# **LAKE CHAPEAU SEDIMENT INPUT AND HYDROLOGIC RESTORATION (TE-26)**

## **I. INTRODUCTION**

Joy Merino, NMFS  
Marty Floyd, NRCS  
John Jurgensen, NRCS  
Elaine Lear, LDNR  
Darin Lee, LDNR  
Mark Hester, LSU  
Jeanene Peckham, EPA  
Greg Steyer, USGS  
Darryl Clark, USFWS  
David Burkholder, LDNR  
Hilary Thibodaux, LDNR

Figure 2. Percent of Time Flooded for Lake Chapeau Sediment Input and Hydrologic Restoration (TE-26).

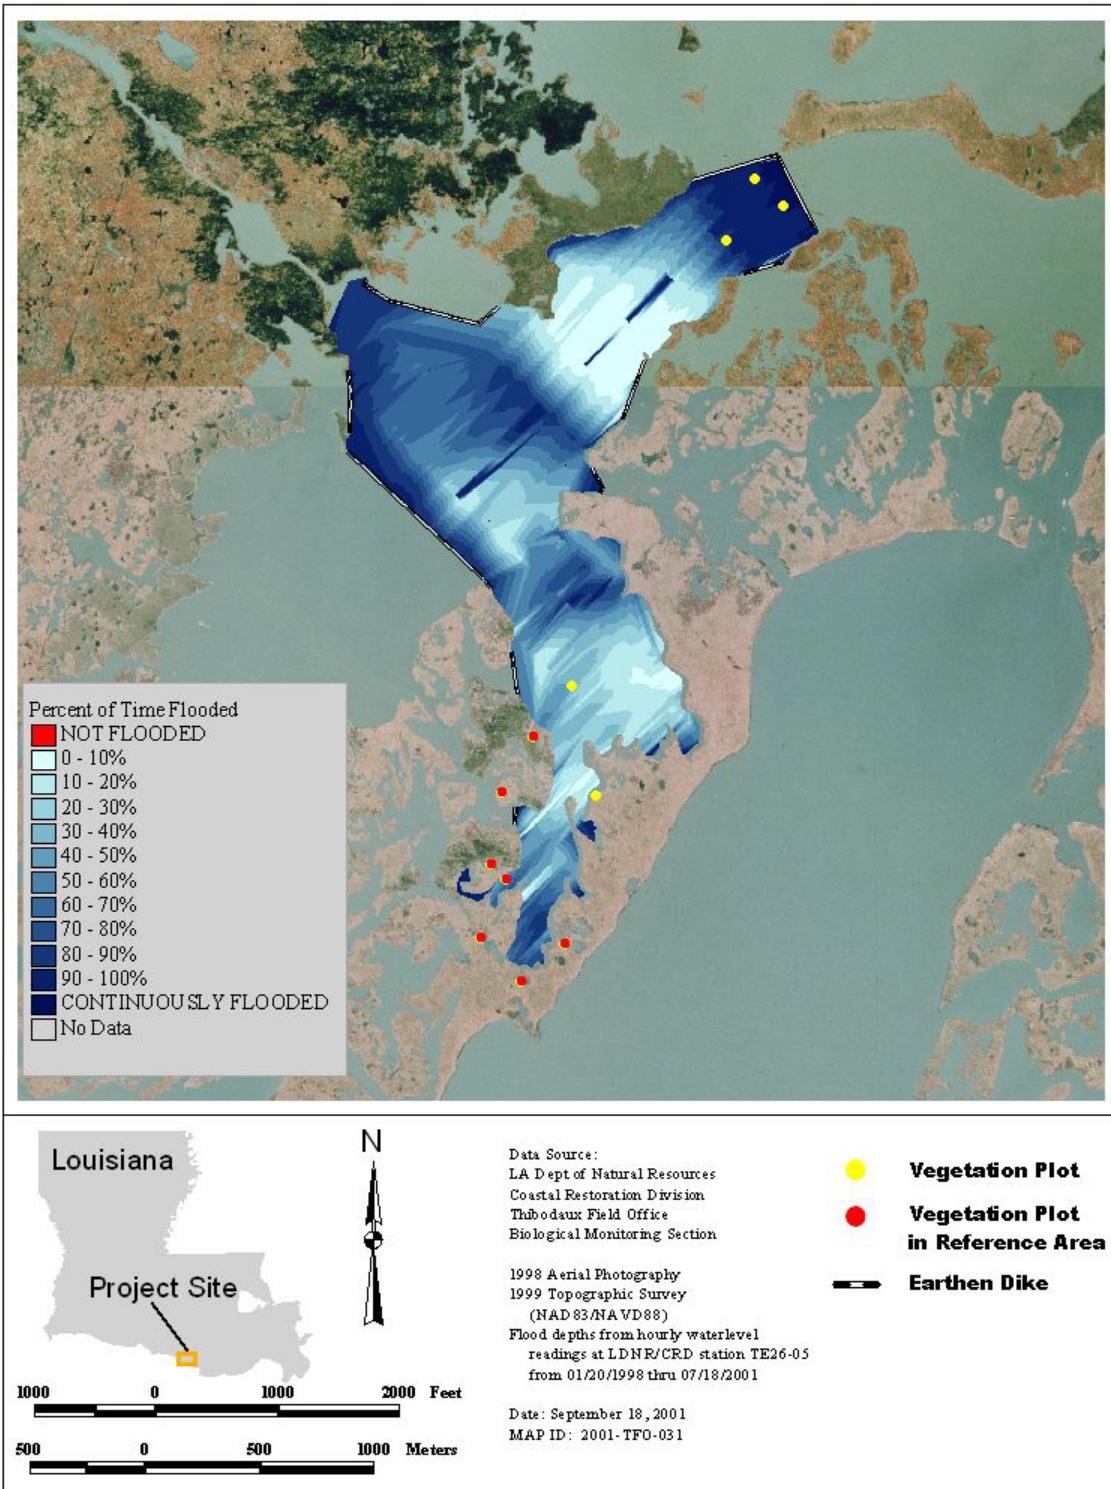
No, the dredged spoil area is at a lower elevation and is flooded more often and deeper than surrounding marshes (Figure 2). Roughly 30% of the dredged fill area was flooded more than 60% of the time (Table 1).

**Figure 3. Mean Percent Cover of Selected Species on the Dredge Material Fill Area at Lake Chapeau Hydrologic Restoration (TE-26) Project for 1999 and 2001 (LDNR)**

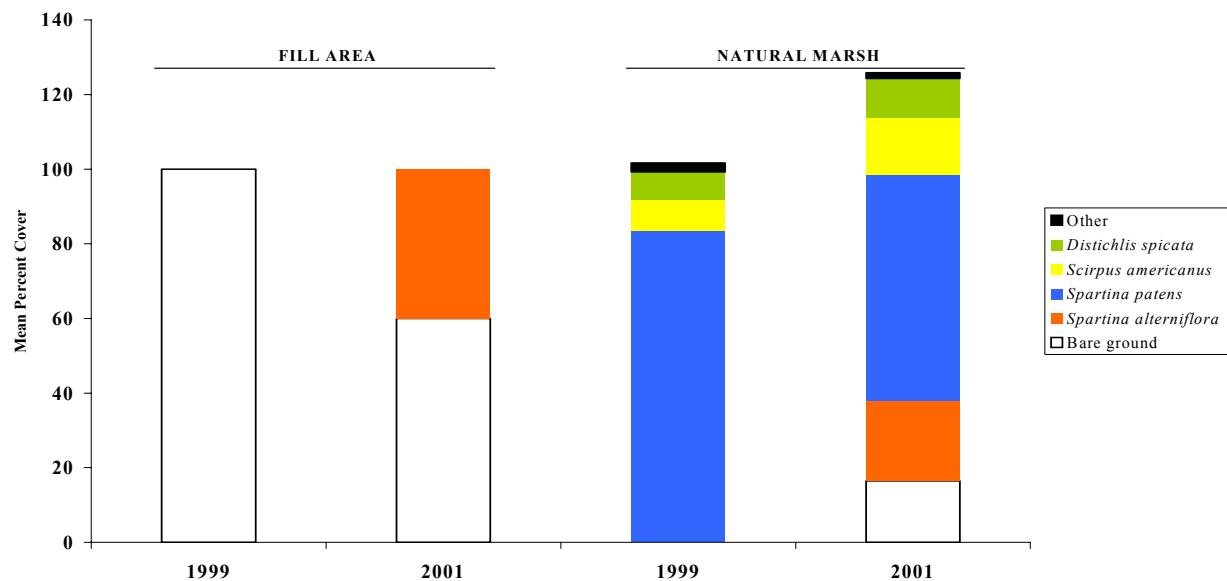
Percent cover of species combined is around 80% in the natural marsh. Percent cover in the reference plots of the fill area was around 40 % (Figure 3), which is half the coverage of the natural marsh. However, the reference plot locations were randomly selected prior to construction. Three of the five reference plots are in the north fill area that is flooded more than 80% of the time (Figure 2). Of the fill area above water, cover is similar to surrounding marshes at 80% cover (personal communication from Rick Hartman, NMFS and Darin Lee, LDNR).

No. *S. alterniflora* was planted in April 2000 and was the only species present in the fill area in 2001 vegetative plots (Figure 1). So the species composition is different from the natural marsh for the first year after planting (Figure 3).
